Environmental Planning Commission

Agenda Number: 3
Project #: 2021-005301
Case #: SI-2021-00452
Hearing Date: July 15, 2021

Supplemental Staff Report

**RE: DUTCH BROTHERS MAJOR AMENDMENT 7 BAR- EPC
RESPONSE TO COMMENTS PR-2021-005301/SI-2021-00452
3615 HWY 528, ALBUQUERQUE NM 87114
ZONE ATLAS PAGE A-14-Z**

SHEET NAME:

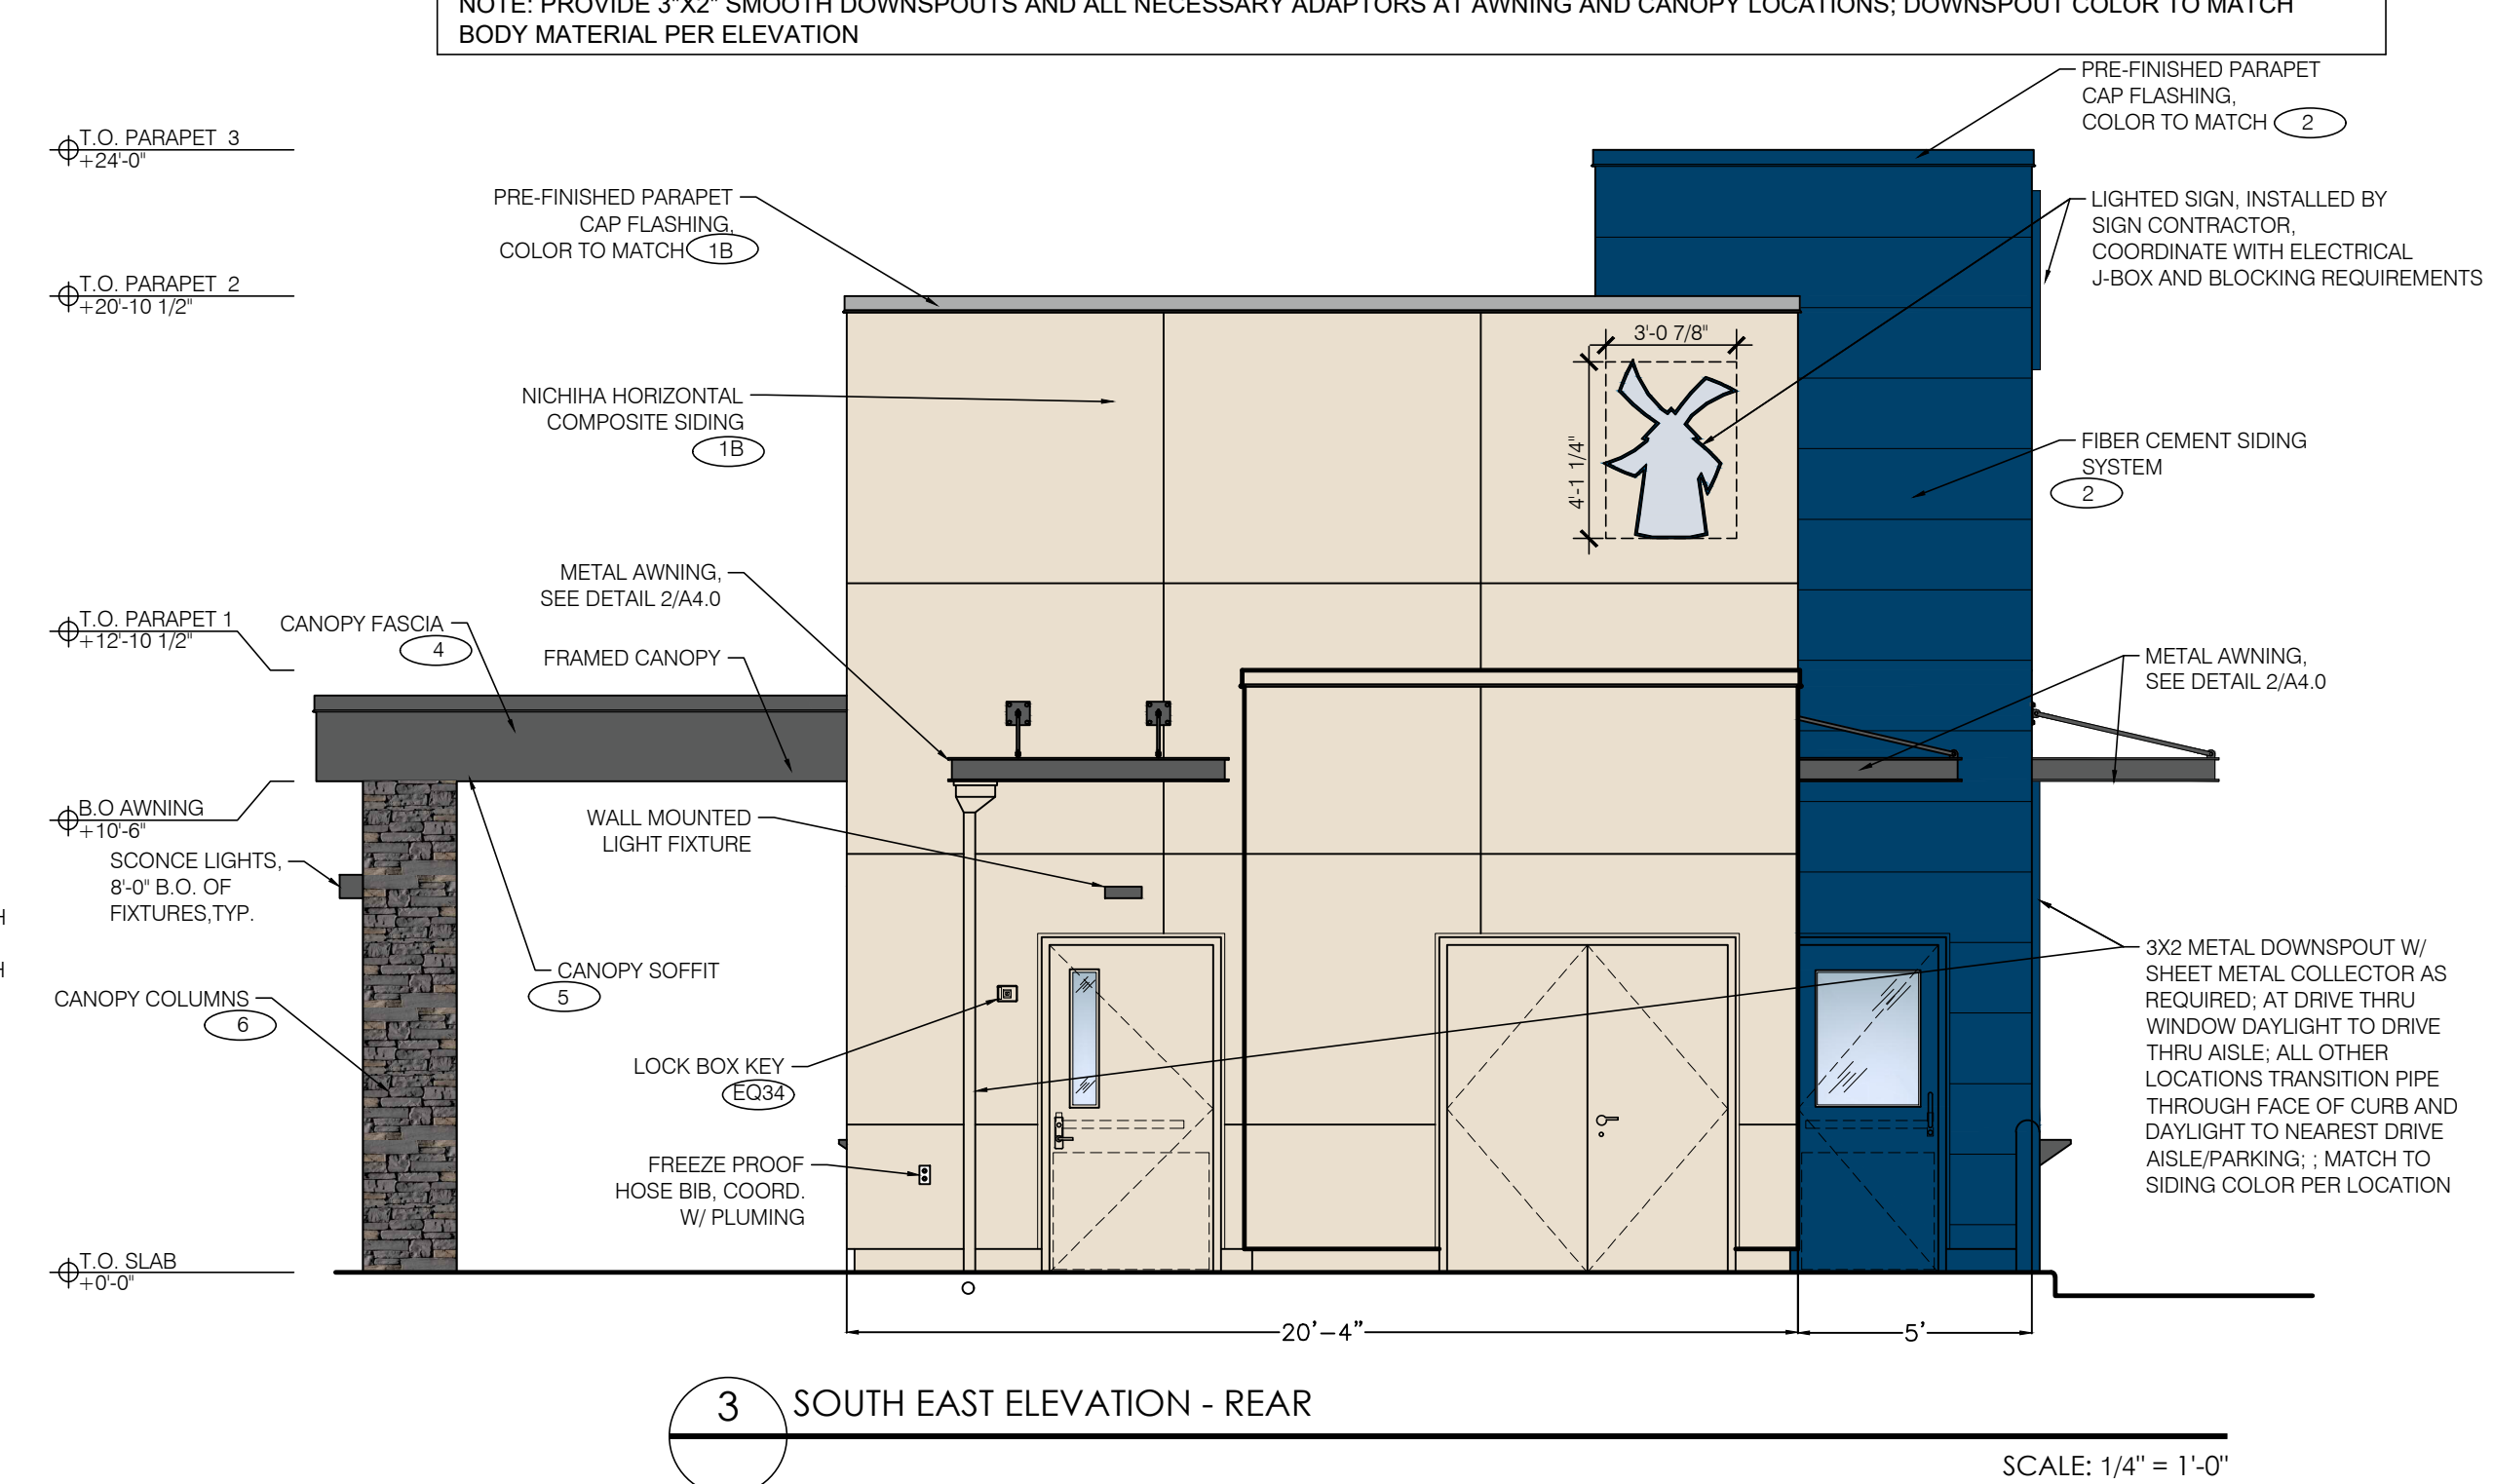
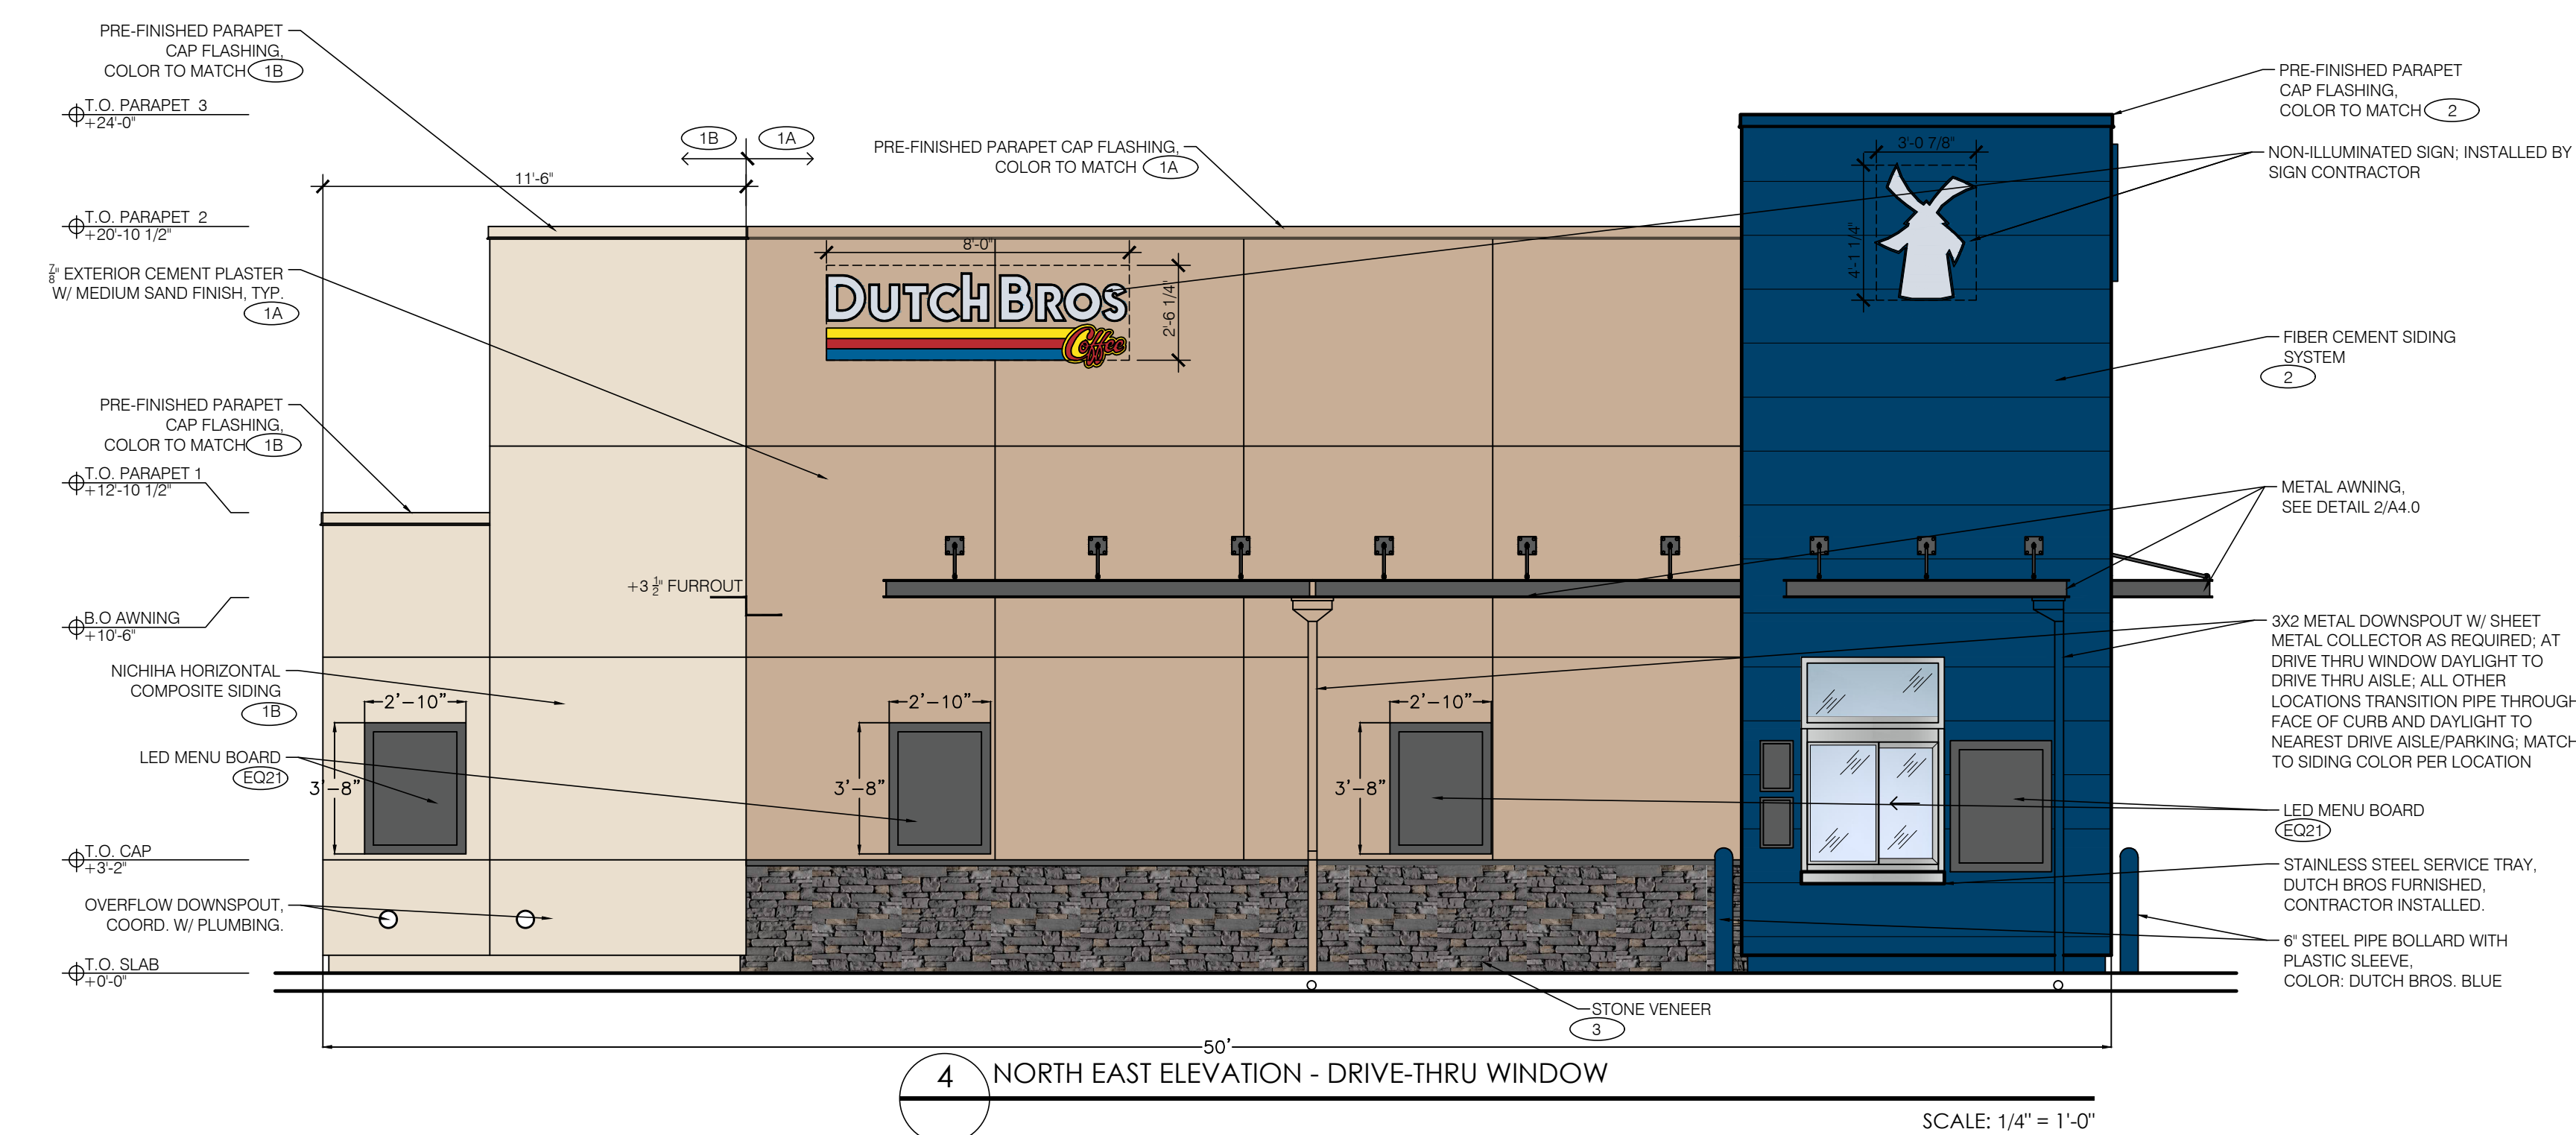
Additional building-mounted signage was added in the form of order boards: 3 new order boards on the SW elevation and 2 on the NE elevation, which faces the neighborhood. Neighbors have requested that no signage face them; a compromise is to remove the approximately 20 sf brand name sign (the square footage of which is made up for by the addition of more order boards). The logo sign on the northeast elevation should not be illuminated since it faces the neighborhood, though the logo sign facing the roadway would remain illuminated.

Response: Building mounted LED menu boards located on south west elevation faces the NM 528 ROW. Revision made to landscaping plan sheet LS-01, two pine trees were added just west of the Dutch Brothers to screen the view from NM 528. Order boards are dimensioned on the elevation plans sheet A6.1. Per the dimensions shown the gross sf of the menu boards do not exceed 50 sf with a total of 44.15 sf on either face of the building.

Response: Revisions made to elevations, sheet A6.1.
